# **INL FY12 Submittals for the Can-In-Can Proposal**

**INL FY12  
End of Year Submittals for the  
Can in Can Concept**

**FCRD-UFD-2012-000327  
INL/EXT-12-27133**

## Engineering Analysis Control Account Drawing Review Comments

<p>DRAWING APPROVALS</p>	<p>DATE</p>	<p>DWG NO. 235-UFD-1000</p>
--------------------------	-------------	-----------------------------

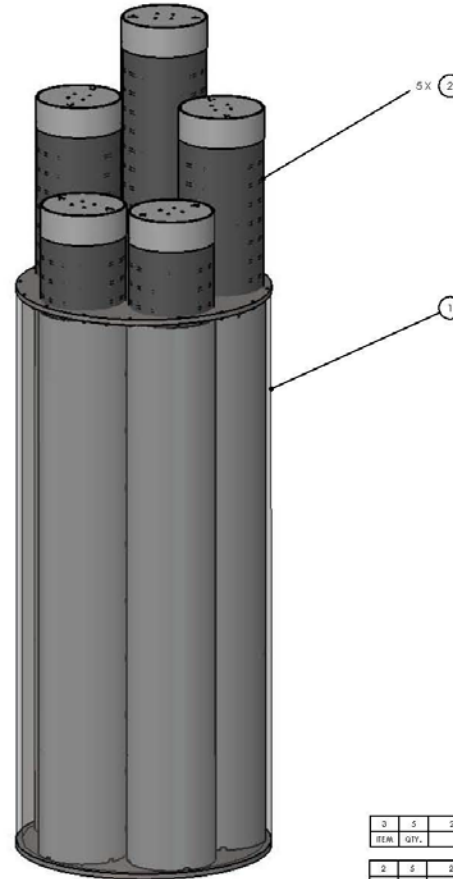
Dwg. No.	Sheet	Comments
235-UFD-1000	1/1	Material call-outs have no detailed material specifications identified (i.e. ASME SA-240 or SA-312, etc.). <i>This comment is applicable throughout the series of drawings (see General Comment below).</i> Delete confusing ASM notations if referring to ASM International or if referring to an assembly, use some term more recognizable. <i>This comment is applicable throughout.</i>
235-UFD-1000	1/1	The note "material certifications required" is somewhat odd. Typical note would indicate "Certified Material Test Reports" (CMTR's) required". However, by indicating Section III compliance, that is already addressed in the Code. <i>This comment is applicable throughout the series of drawings.</i>
235-UFD-1000	1/1	Add notation under PWR canister
235-UFD-2000	1/2	There appear to be four swivel eyebolts on the lid of the can. However, there are no apparent detailed call-outs (rated load in material list) for these items nor any preload requirements identified.

DRAWING NO. 235-UFD-2000

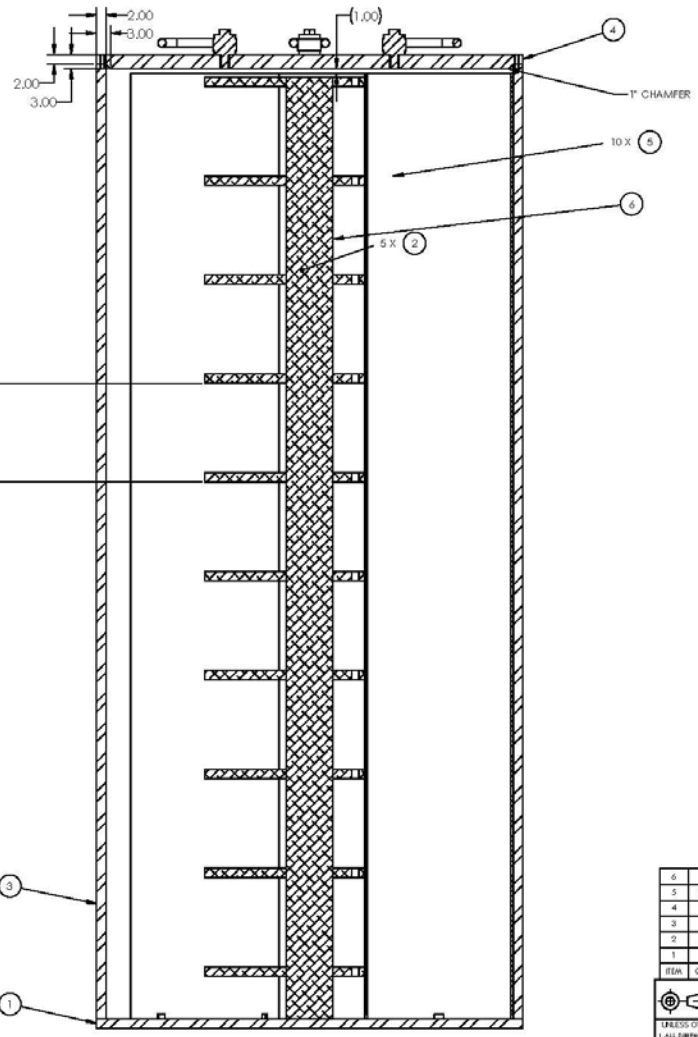
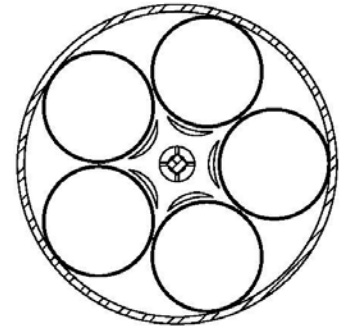
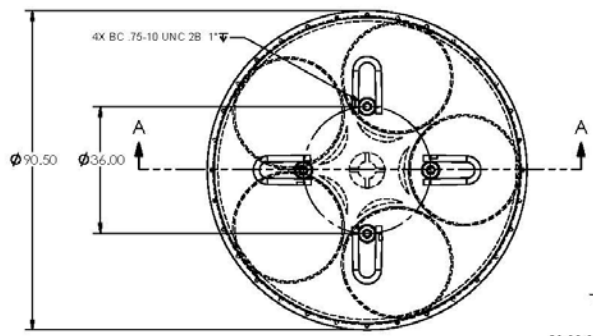
235-UFD-2000	1/2	Item #3 (shell material) is identified as aluminum but should be 316 SST (previously noted at 2/14/2012 meeting). Is the shell expected to be fabricated from rolled plate or otherwise?
235-UFD-2000	1/2	Labeling font sizes are not consistent. <i>This comment is applicable throughout many of the drawings.</i> Larger font sizes are helpful for easier reading.
235-UFD-2000	1/2	If the top lid is to be bolted on (as indicated at the 2/14/2012 meeting), a reinforced ring at the top lip of the shell would be necessary in order to have sufficient material for the bolts to engage and carry the required loading. What size bolts would be used and preload info? Thread type is important if installed remotely.
235-UFD-2000	1/2	Have cathodic/anodic reactions been considered with the materials indicated?
235-UFD-2000	1/2	Indication for Item #2 location appears to be in error. Isn't that the star rod?

F/N 2 LARGE CAN SUPPORT TUBE  
SCALE 1:4

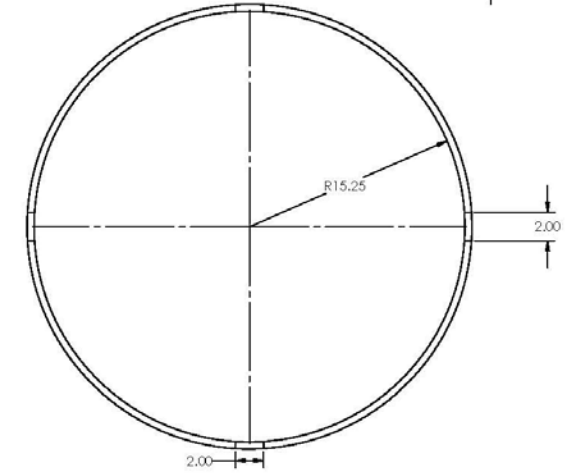
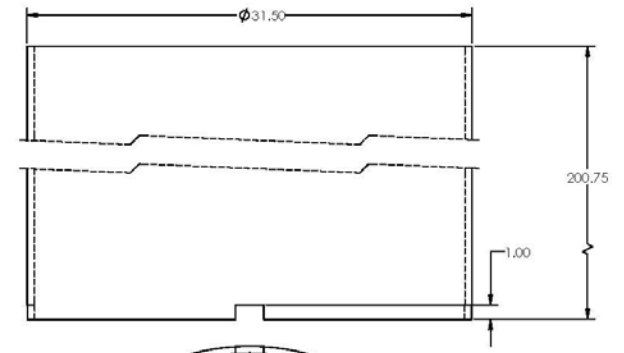
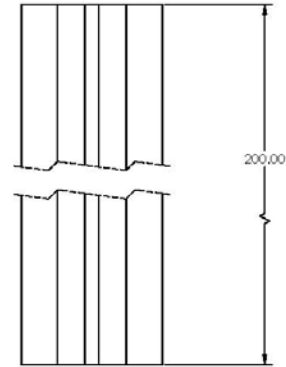
235-UFD-2000	2/2	The support tube shows a 30.5 inch circular ID but the smaller fuel canisters have a 30.5 inch circular OD. There is no tolerance to account for ovality and curvature along the length. These components cannot be loaded into each other.
235-UFD-2000	2/2	What does "F/N" mean where a part is "detailed"? <i>This comment is applicable throughout many of the drawings.</i>
235-UFD-2000	2/2	Where are the detailed drawings for the can top and bottom lids?
235-UFD-2000	2/2	Not sure if sufficient dimensions are provided to fabricate the support star. What are the radius values? Can the support tubes physically fit between the support star and the wall of the larger canister, considering maximum tolerances? How are the support stars attached to the star rod?
235-UFD-3000	1/1	Is the borated steel divider all borated material? What are the 4-inch wide end pieces for?

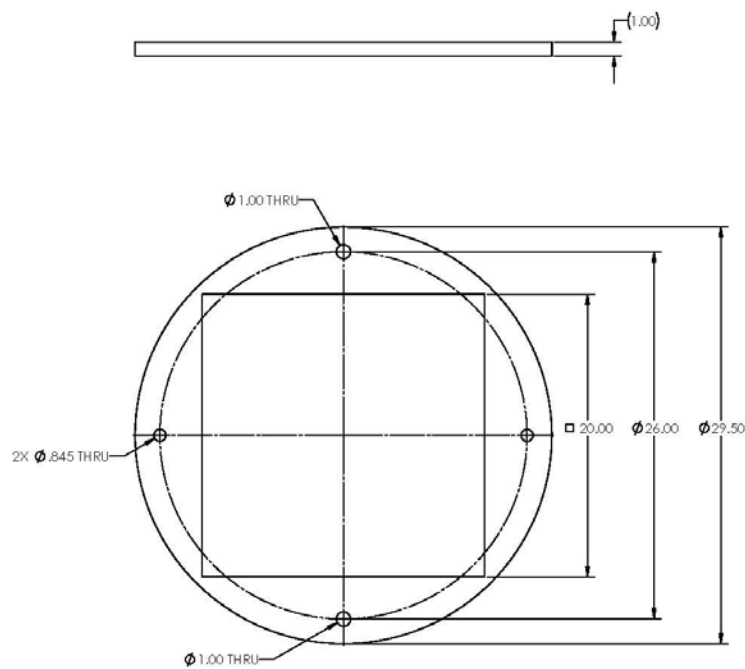
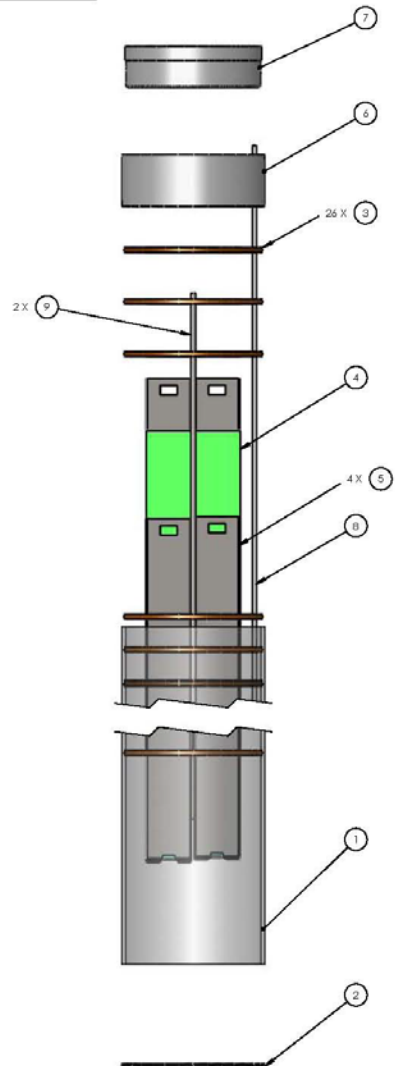
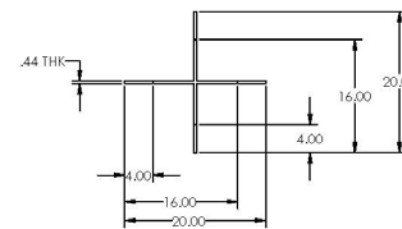
235-UFD-3000	1/1	The title given to components seems backwards. The larger component should be the canister and the smaller component (with fuel assemblies) should be a can. This change would then better match industry and regulatory terminology.
235-UFD-3000	1/1	What specific type of borated SST is being used? Does this provide any structural functions?
235-UFD-3000	1/1	Hole dimension of 0.845 seem very tight for ½ " NPS and over the length of the pipe.
235-UFD-3000	1/1	What is the spacing between Items 3 (quantity of 26) on this sheet? What type of steel?
235-UFD-3000	1/1	Minimal dimensional and fabrication details are provided for the PWR smaller can.
235-UFD-3100	1/1	Inconsistent dimensional call-outs: decimal versus fractional in material list.
235-UFD-3100	1/1	What is the hole diameter for the hole at the center of "F/N 4 PWR Sheath Botom"? (spelling error)
235-UFD-3100	1/1	On Item 1: it's not clear what the notch dimensions for the rectangular cut outs at the bottom of this item are.

DRAWING NO. 235-UF4-4000

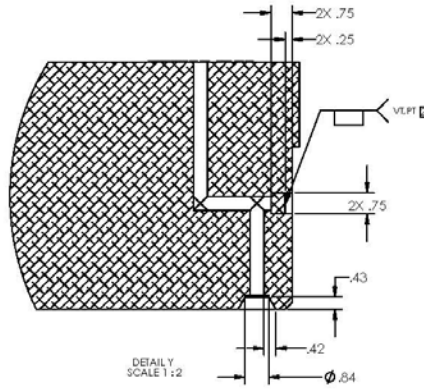
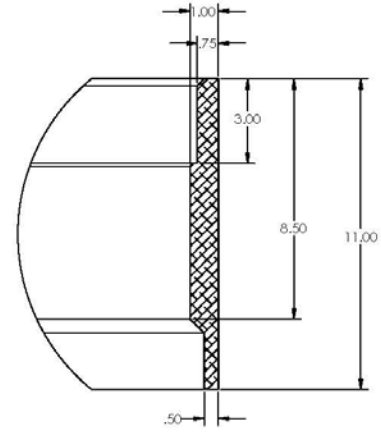
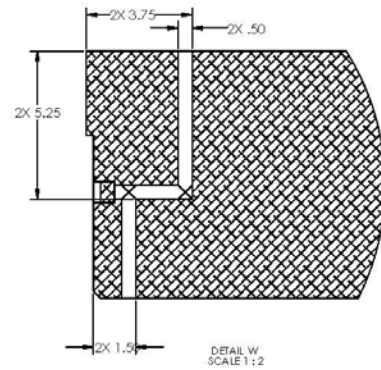
235-UFD-4000	1/4	No comments.
235-UFD-4000	2/4	The curved faces of the plug cross-sections are misleading as drawn. Does the plug weld have any functions requiring rigorous examinations?
235-UFD-4000	3/4	It is not readily apparent what details are being provided in 'Detail M', the 3.56 wide segments?
235-UFD-4000	4/4	The thickness dimension of the bottom lid (2" thick) conflicts with callout on Sheet 1/4 (mentioned in 2/14/2012 meeting).
235-UFD-4100	1/2	No comments.
235-UFD-4100	2/2	No comments.
General Comment	#1	The details of these assemblies are not as clear as they need to be. Drawing must reflect the information necessary to fabricate and analyze these components.
General Comment	#2	The lack of detailed material specifications and welded or bolted connection details makes any valid structural analysis of this assembly currently impossible to complete.
General Comment	#3	The assumption has been made herein that construction will be per ASME BPV Code, Section III requirements (Division 3 is preferable). Drawings should so state in Notes.
